ALTERATION TO A HISTORIC PROPERTY STAFF REPORT

Site: 88 College Avenue c.1890 Charles H. Lockhart House
Case: HPC 2015.009 Westwood Road Local Historic District

Date of Application: January 28, 2015
Legal Notice: *Install a finial on turret.*

- ③ FROST RESIDENCE RESTORATION
88 COLLEGE AVE, SOMERVILLE
FINAL PROJECT
CURRENT TOWER W/ FINAL ADDED (TO SCALE)

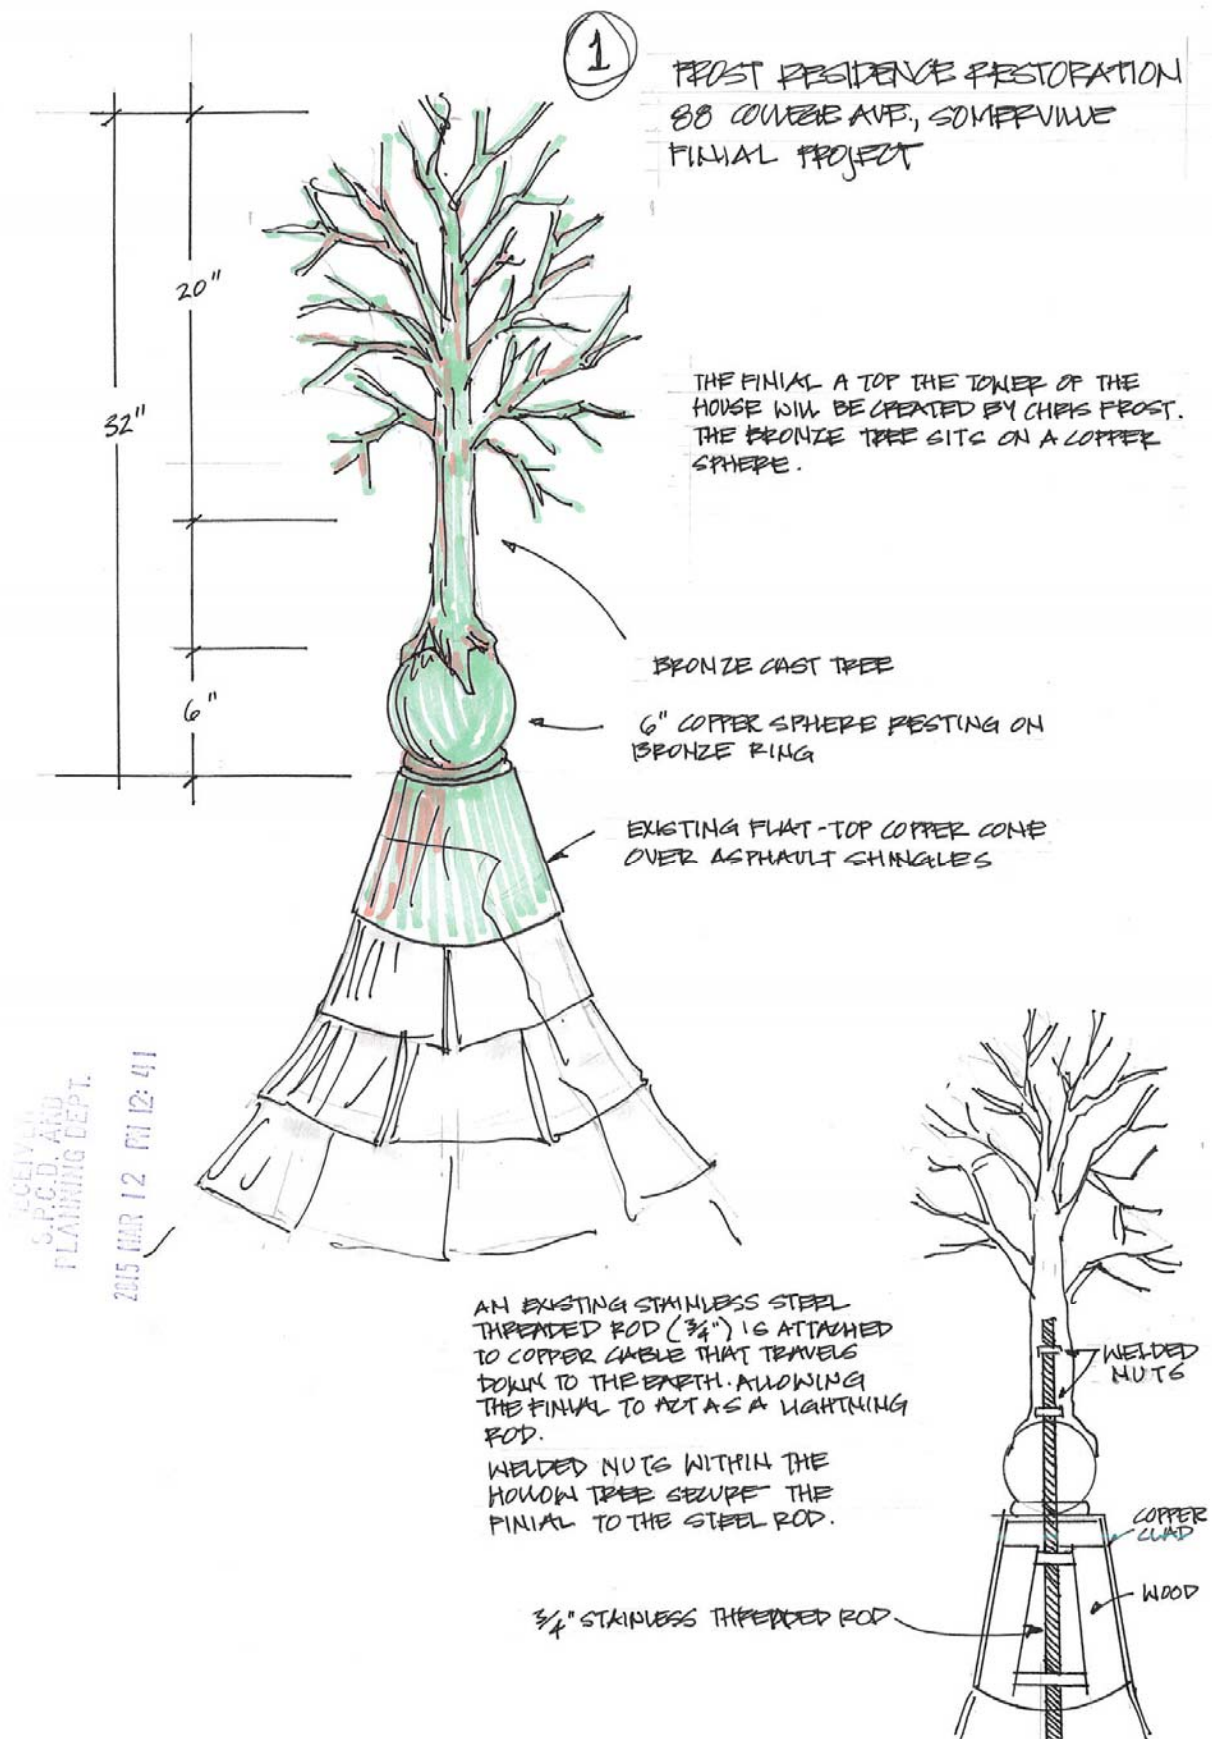
The tower is missing its finial. The historic photograph of the house indicates that there was one. Its exact size and proportions are not known although one might be able to derive them from the historic photo.

A finial is an appropriate element for the towers of Queen Anne structures. The proposed ornament is reversible and has a modern approach that would never be mistaken for a historic ornament.

The proposed ornament does not match any historic feature. Only its location is based on photographic and physical evidence.

The proposed finial ornament is constructed of bronze and copper.

Staff determines that the alteration for which an application for a Historic Certificate has been filed is appropriate for and compatible with the preservation and protection of the 88 College Avenue Local Historic District; therefore **Staff recommends that the Historic Preservation Commission grant Christopher and Melissa Frost, Owners a Certificate of Appropriateness** for the following.

1. The finial sculpture shall be installed in a manner that is reversible.
